NEWTOWN TO CITY  
TRANSITIONAL CYCLEWAY  
90% DETAILED DESIGN ROAD SAFETY AUDIT  
PREPARED FOR WELLINGTON CITY COUNCIL  
March 2022

## Newtown to City Transitional Cycleway 90% Detailed Design Road Safety Audit

Figure 2-19: Cycle Path transition through Courtenay Place / Majoribanks St intersection to Oriental Parade

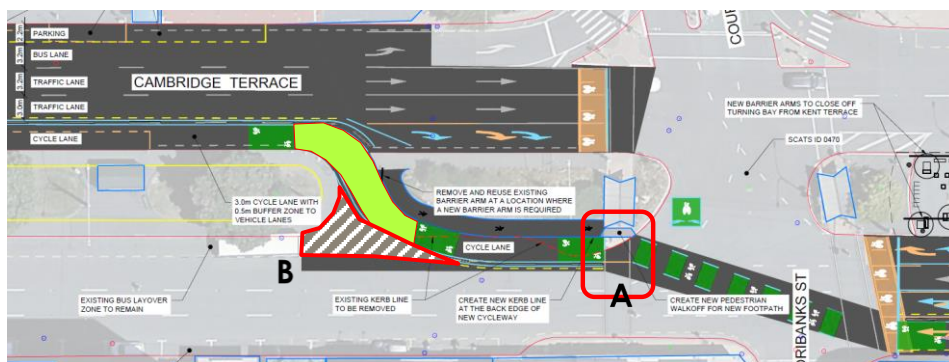
In reviewing this new design, the SAT have considered the interaction between bi-directional cyclists, and pedestrian movements at the chicane. The design currently has minimal green marking on the new cycle lane surface, especially in the path of the pedestrian movement.

In addition to the green markings, it is noted that there appears to be no detail on the required hold lines and signal aspects for the north / south movement. Refer to position A on Figure 2-19 above.

The current design creates an area alongside the cycle facility where a driver could consider that there is a parking space (despite the markings) and artificially creates a wider road aspect. Refer to position B on Figure 2-19 above.

Frequency Crashes are likely to be common	Severity Death or serious injury is likely	Rating The safety concern is significant
Designer response	<ol style="list-style-type: none"> <li>1. Disagree that high-friction surfacing is required, there is nothing to suggest that the current asphalt surface will become slippery in wet conditions when traversed at an appropriate speed. Pedestrian demand across this path is very low and cycle speeds should be low. The cycle separators include vertical delineators at either end which will provide a visual screen especially given the approach angle of vehicles. Current crossing facility has no tactiles or drop-kerbs, layout of this area is likely to change multiple times over the coming few years (including as part of the Golden Mile project) suggest improved pedestrian facilities are provided as part of a more permanent design.</li> <li>2. Agree with SAT</li> <li>3. Agree with SAT</li> <li>4. Agree with SAT – signal information should be provided.</li> </ol>

Safety Engineer comment	<ol style="list-style-type: none"> <li>1. Agree with Designer. Behaviour at this location to be monitored and site modified if necessary.</li> <li>2. Agree with SAT and Designer.</li> <li>3. Agree with SAT and Designer.</li> <li>4. Agree with SAT and Designer.</li> </ol>	
Client decision	Agree with above	
Action taken	No action required

Figure 2-20: Cycle hook turn box located within intersection

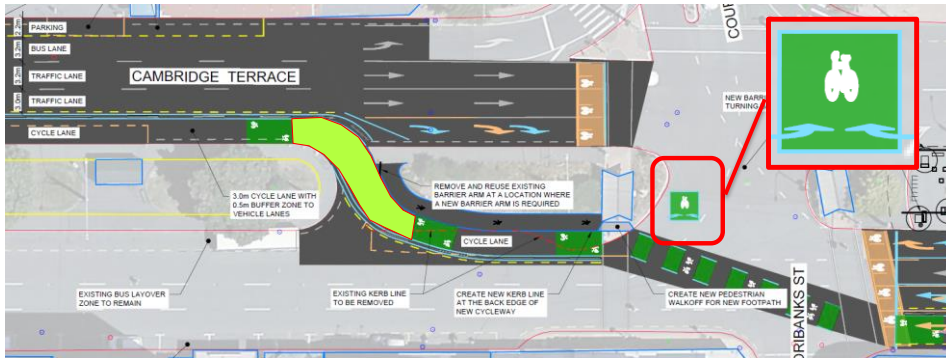
Arrows within the box (see insert above) indicates that the hook turn box is to accommodate the right turn in / left turn in for cyclists into Courtenay Place.

The SAT have significant concerns that this hook turn movement appears to occur in the right hand out bound lane from Courtenay Place and is in direct conflict with this movement. As stated previously, traffic signal phase diagrams were not supplied for this project. The SAT consider that the hook turn box is not in a safe position given the complex movements observed at the intersection.

Frequency	Severity	Rating
Crashes are likely to be common	Death or serious injury is likely	The safety concern is significant
Designer response	Agree with concern raised by SAT with 90% design. Design to be updated to relocate hook turn and redefine turning paths from Courtenay Place. Working sketch below:

Safety Engineer comment	Agree with Designer.
Client decision	Agree with above
Action taken	No action required

Figure 2-21: Proposed Oriental Parade Crossing point

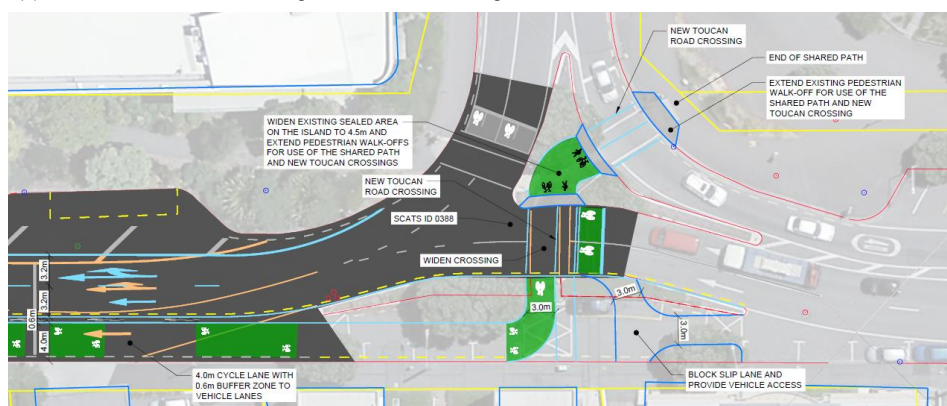
The SAT identified that the proposed alignment has some elements that require further consideration. These include:

1. The pedestrian crossing leads directly into an existing kiosk (refer to Figure 2-25). The kiosk would require relocation to eliminate the hazard for the pedestrian movement.

2. The new alignment indicates that a mature tree would be removed to facilitate the new facility. The SAT consider that there is potential to retain the tree yet maintain the same level of access movement, by traversing around the tree. (Refer to Figure 2-22)

3. The tree is located at a position where there is an existing speed hump. Retention of the tree, and the speed hump will assist in speed moderation approaching the new crossing point. (Refer to Figure 2-22)

4. Existing high hedge type planting exists at the crossing point over Oriental Parade. (Refer to Figure 2-23 and Figure 2-24). This hedge is sufficiently high as to restrict the intervisibility between pedestrians / cyclists and the approaching traffic coming from Oriental Parade. The hedge should be trimmed / removed to maintain appropriate intervisibility.

Figure 3-1: Alternate cyclist linkage to/from Courtenay Place

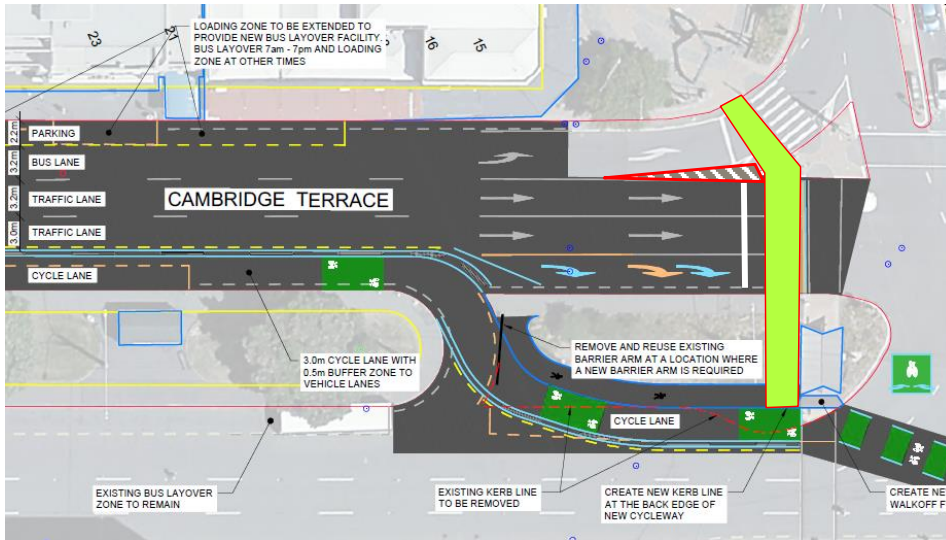
The current pedestrian crossing south of the intersection has a suitable level of service for pedestrians, however this would not be suitable to incorporate cyclists as part of the crossing movement on the current crossing point. Access to the existing path through the central median also occurs immediately adjacent to the lane shift of the new facility.

The SAT consider that there is a possible alternate linkage for cyclists from the new bi-directional facility, through the central island and across into Courtenay Place, running parallel with the current facility, as indicated in Figure 3-1 above.

This could be achieved through the formation of a new path through the central median, with porous pavers over the garden to maintain tree health. The limit line of the northbound movement can be moved back to facilitate the inclusion of a new crossing feature, ASB for through movements, and inclusion of a longer splitter island.
